FIRE SAFETY FOLLOW UP INSPECTION

Factory Name	Multifabs Ltd		
Address	Kashimpur, Nayapara, Gazipur		
Inspection Date	04/09/2014		
Date Report Received	01-June/14		
Date of 1st Follow-up	28-July/15	Date of 2nd Follow-up	03-February/16
Date of 3rd Follow-up	18-April/16	Date of 4th Follow-up	01-August/16
Date of 5th Follow-up	26-October/16		
Inspected by	Md. Anayet Hossain.

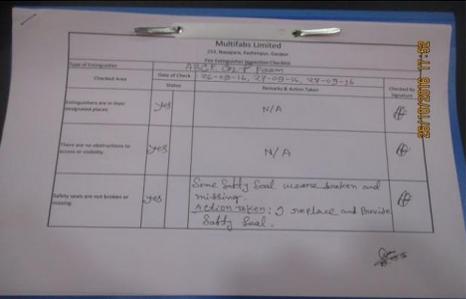
8	Exit access corridors are not provided with 1 hr. fire resistance rating or approved NFPA 13 sprinkler system on the ninth floor.	Provide exit access corridors with 1 hr. fire resistance rating or approved NFPA 13 sprinkler system.	Within 3 months	On 03/02/16: Fire door installation in progress. On 18/04/16: Interfacing for the fire doors is required. Accessories (vision panel) shall have to be fixed properly. On 01/08/2016: Corrected. On 26/10/2016: Corrected.	30/06/2016		Corrected	
---	---	---	-----------------	---	------------	--	-----------	--

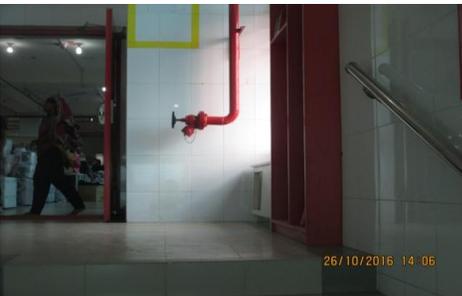
9	Storage rooms discharge directly into all exit stair enclosures.	Openings from exit enclosure to storage spaces shall be provided with a vestibule with fire rated construction and openings. Provide a 1.5 hr. fire rated door on the exit stair side and	Within 3 months	On 03/02/16: Partially corrected. Installation in progress. On 18/04/16: Interfacing for the fire doors is required. Accessories (vision panel) shall have to be fixed properly. On 01/08/2016: Corrected. Store rooms discharges directly into exit stair are provided with fire doors and installed doors are interfaced with Fire Alarm Control Panel. On 26/10/2016: Corrected.	30/06/2016		Corrected	
---	--	--	-----------------	---	------------	--	-----------	---

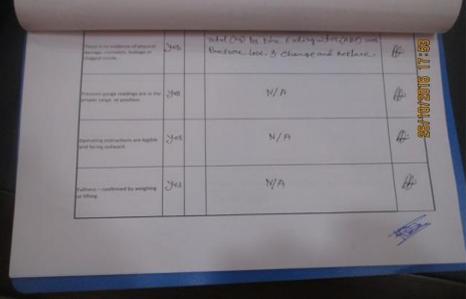
44	The required no smoking signs are not present in the factory.	Smoking is prohibited in any garment factory building or separate storage building. Signs shall be posted in Bengali and English at all building entrances. If the factory creates a designated smoking area outside the building, information of these areas will be posted on the signs.	Within 1 month	On 03/02/16: Corrected. On 18/04/16: Corrected. Provided. On 01/08/2016: Corrected. On 26/10/2016: Corrected.	01/08/2014		Corrected	
45	Inspection, testing and maintenance for the fire alarm system is not in accordance with NFPA 72.	Inspect, test and maintain the fire alarm system and keep written records on-site, in accordance with NFPA 72.	Within 3 months	On 03/02/16: It is an integrated part of fire alarm system. On 18/04/16: It is an integrated part of fire alarm system. On 01/08/2016: Maintaing ITM for existing system. On 26/10/2016: Corrected.	30/06/2016		Corrected
